SUBJECT: NuScale Power, LLC Supplemental Response to NRC Request for Additional Information No. 185 (eRAI No. 8963) on the NuScale Design Certification Application

NuScale Supplemental Response to NRC Request for Additional Information eRAI No. 8963

NRC Question No.: 03.08.05-22

Figure 2-1 CRB Foundation Basemat Plan View

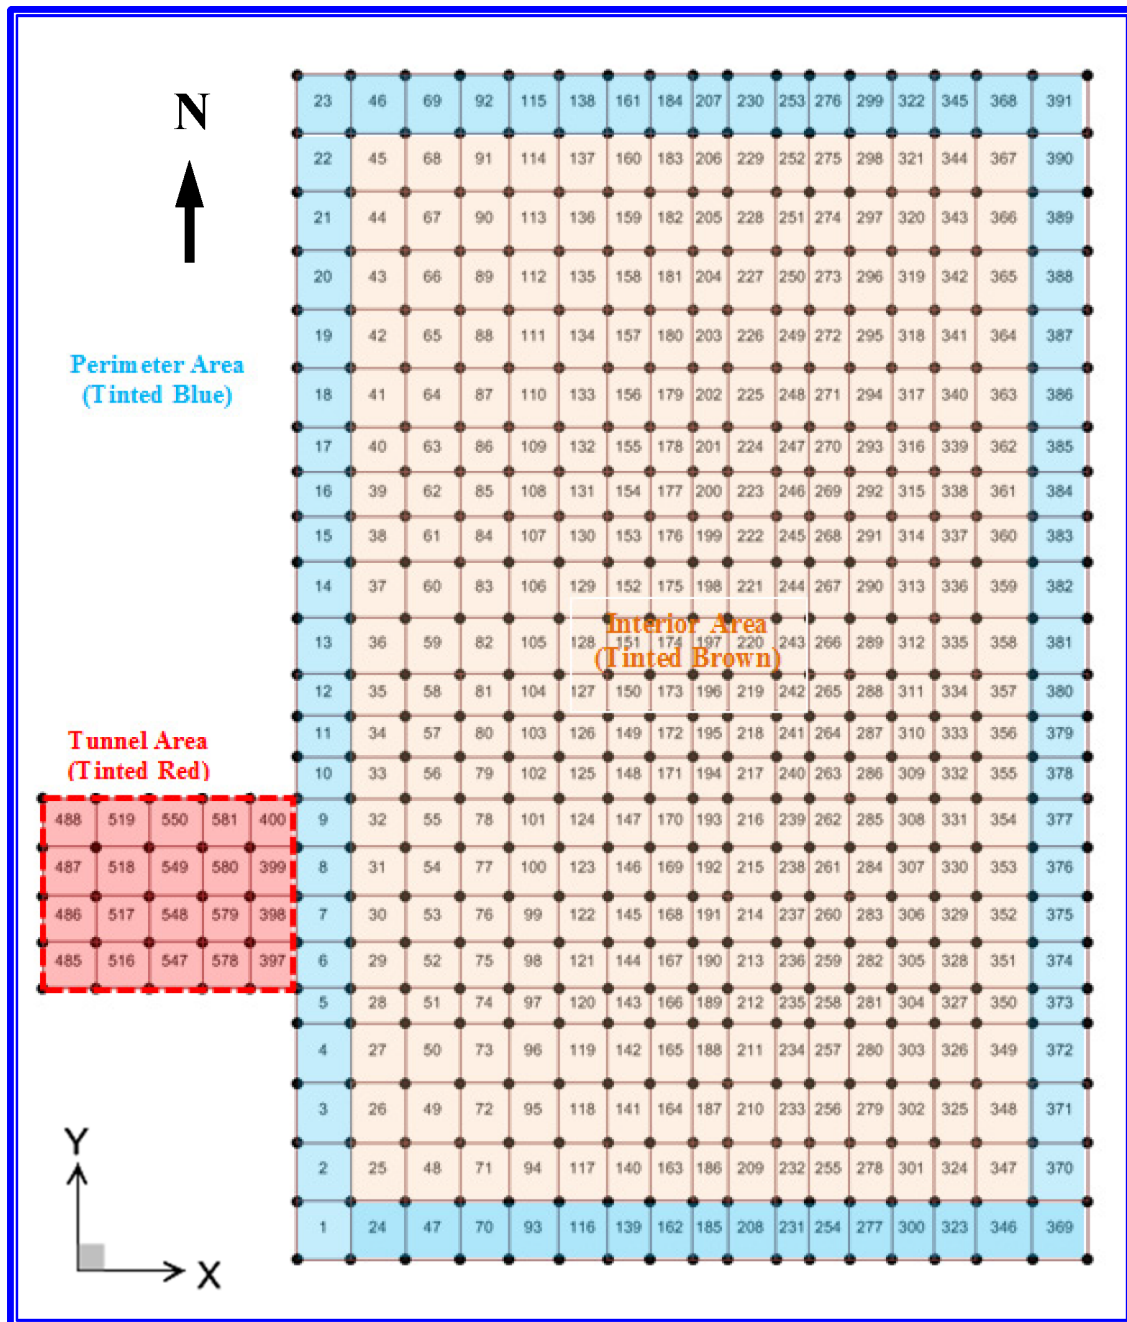
2. Under “Seismic Demand:” the applicant is requested to provide additional information (e.g.; figures, discussions) showing how moments M1, M2, and M3 from the simple supported beams between walls (Figure 2-2), and added wall moments (M1 and M2) were determined from moments of Mxx, Myy, Mxy.

For the seismic moment calculation, the CRB foundation shown in Figure 2-1 was divided into three areas:

- a. Exterior Perimeter Area - uses the moments directly from the exterior wall shell elements and pilaster beam elements in contact with the basemat.
- b. Interior Area - uses a shell element basemat model subjected to seismic soil pressure. Shell elements give the moment directly.
- c. Tunnel Area - the moment was calculated by using the moments in the walls and by using soil pressure. The method is described in Section 2.1 below.

Figure 3-1 CRB Foundation Plan View

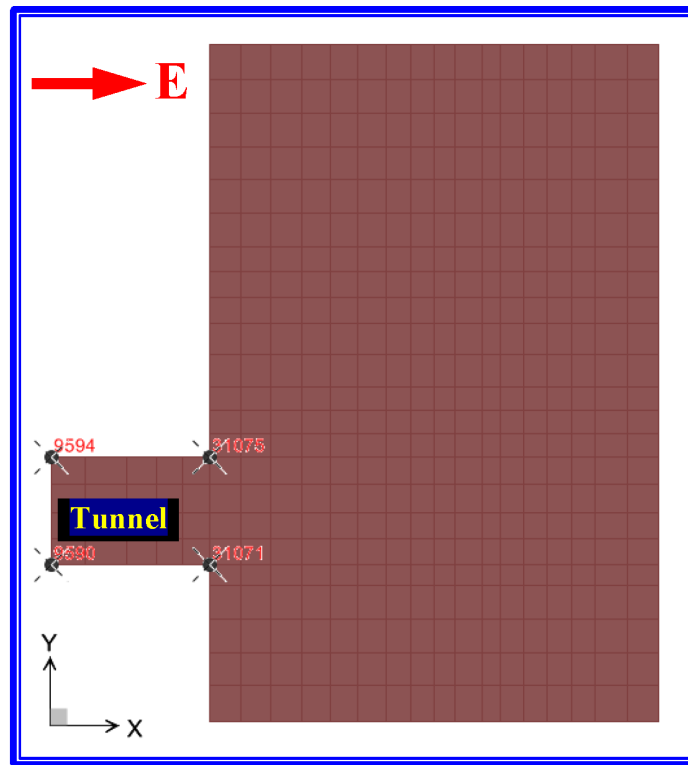
3. Please explain why settlement values were not provided for the CRB Tunnel area.

Response: The CRB tunnel settlement has been calculated. The CRB tunnel settlement is provided herein and FSAR Section 3.8.5 has been updated.

The bottom of the CRB foundation and four tunnel foundation bottom corner nodes are shown in Figure 3-1. The protruding tunnel foundation area is on the west side of the CRB.

**Figure 3.8.5-3: Seismic Base Pressure Contours from SASSI2010 Analysis
in the Reactor Building Basemat ~~Model (Lb, inch Units)~~(psi) (Positive X Axis is to the Right of the Image and
Positive Y is to the Top of the Image)**

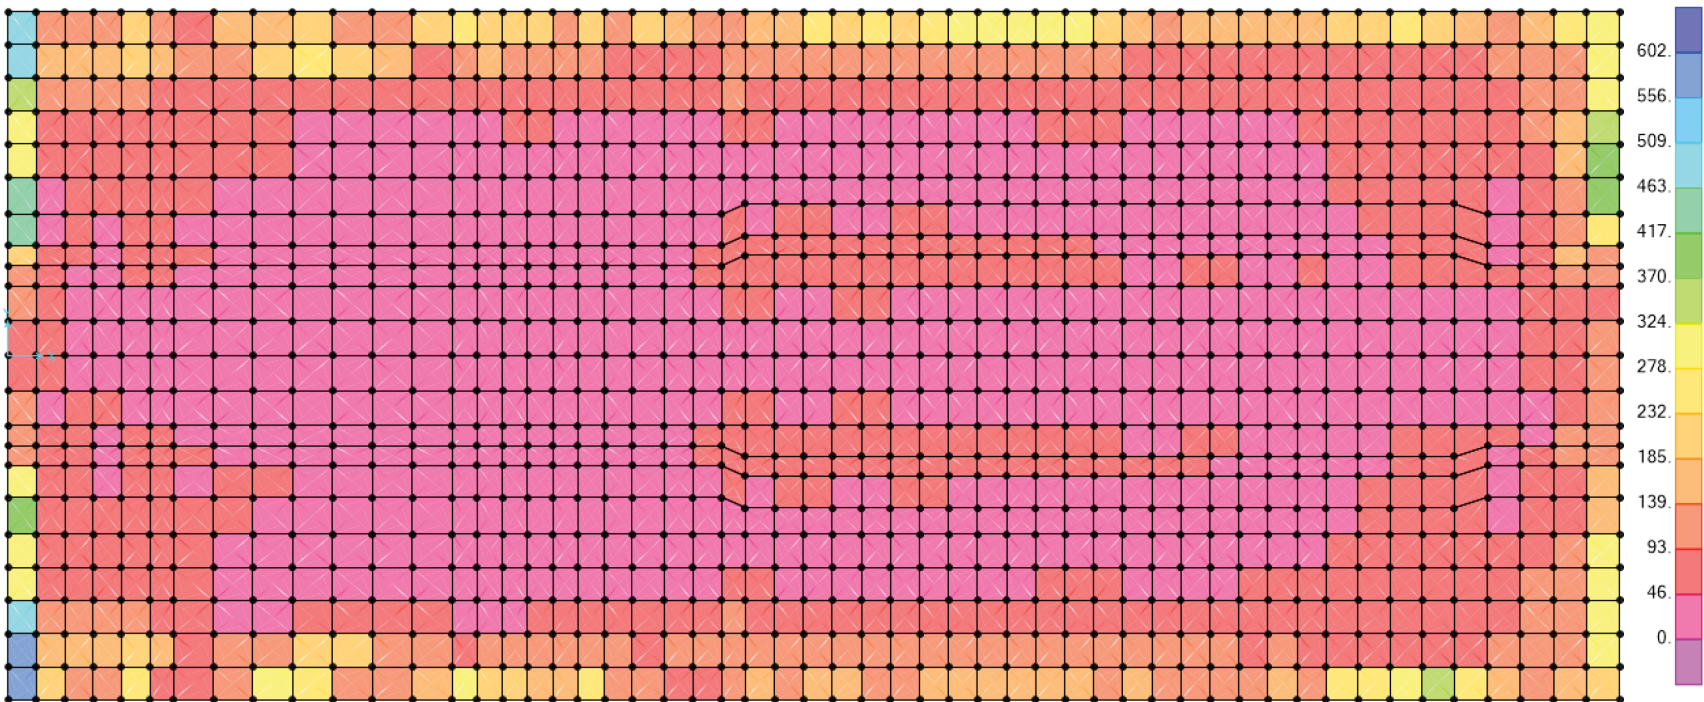
- a. describe the reason(s) why the dynamic bearing pressures of CRB is larger than the dynamic bearing pressures of RXB.
 - b. explain how the applicant determined 4.6 ksf from Figure 3.8.5-3 for the dynamic bearing pressures of RXB basemat.
 - c. address and provide figures of static and seismic basemat pressure contours for the CRB and CRB Tunnel.
-

~~RXB foundation average dynamic pressure is 4.6 ksf. The CRB average foundation dynamic pressure is 2.3 ksf.~~ The RXB foundation average dynamic pressure is 4.6 ksf. The CRB average foundation dynamic pressure on the rectangular basemat is 2.3 ksf. The average dynamic pressure on the tunnel area is not calculated. Maximum dynamic pressures across the entire CRB basemat, including the tunnel basemat, are shown on Figure 3.8.5-3a. These pressures are obtained by the post-processing approach indicated in Section 3.7.2.4.1.

Figure 3.8.5-4: ~~M22 due to Static Base Pressure~~ Myy Due to Static Base Pressure on Reactor Building Basemat (kip-ft/ft) in the Reactor Building Basemat Model (Positive X Axis is to the Right of the Image and Positive Y is to the Top of the Image)

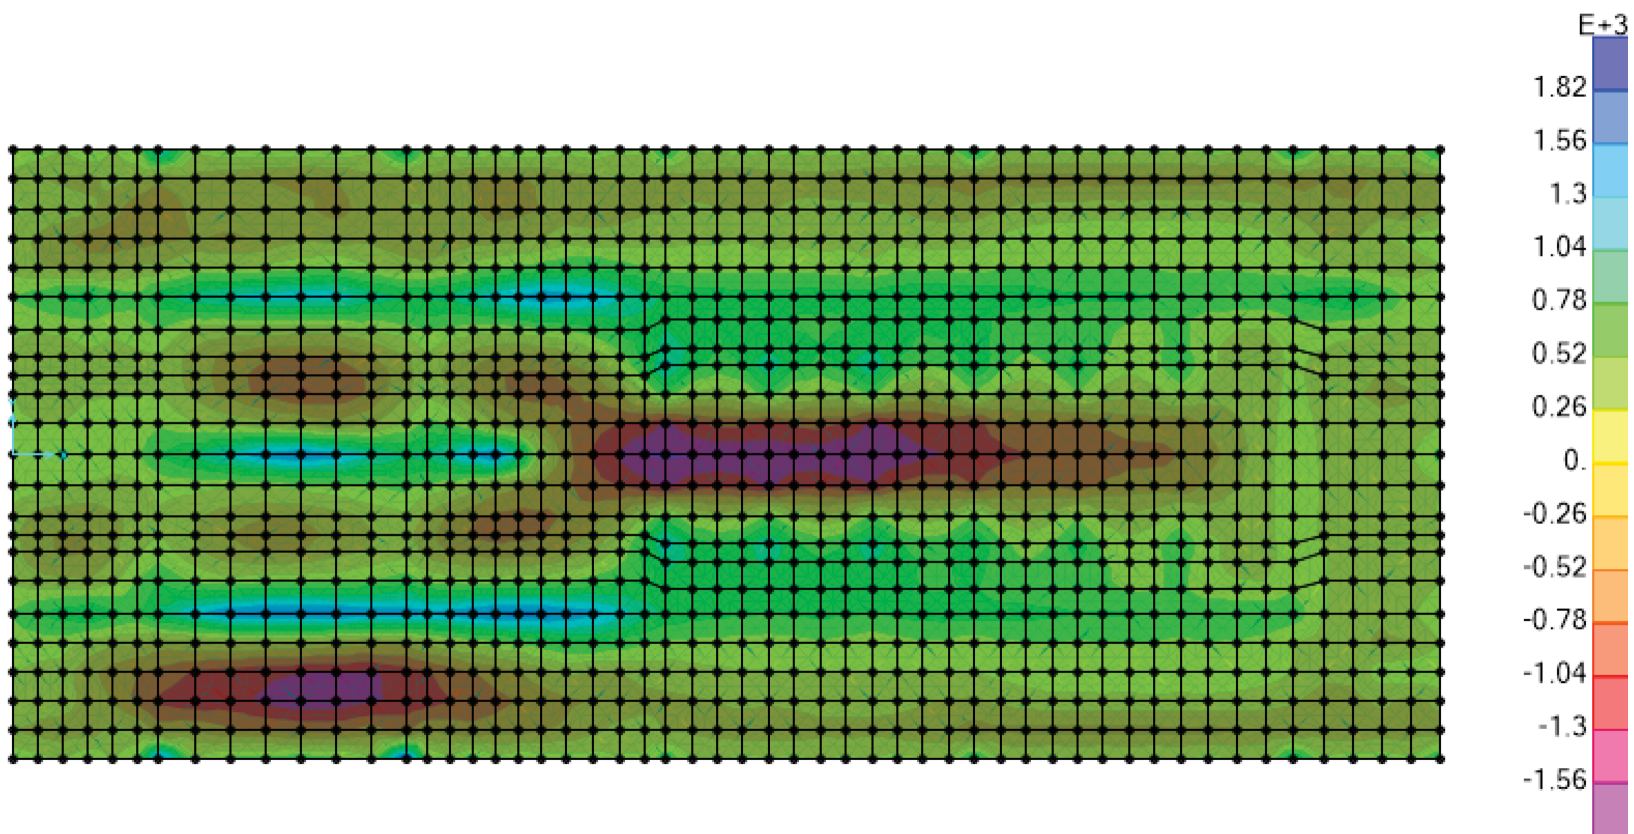
- Figures 3.8.5-4, -4a, -5, 5a, -6, -6a, -7, 7a depict Mxx and Myy of RXB and CRB basemat moments, but the applicant did not provide any description of those moments in the markups and in the body of the FSAR. Please describe and refer those figures in relevant sections of the FSAR.

Response: A description of these moments has been included in the FSAR, and callouts have been added in FSAR Section 3.8.5.4.1.3 for the CRB figures. Callouts for the RXB figures are in FSAR Section 3.8.5.4.1.2.
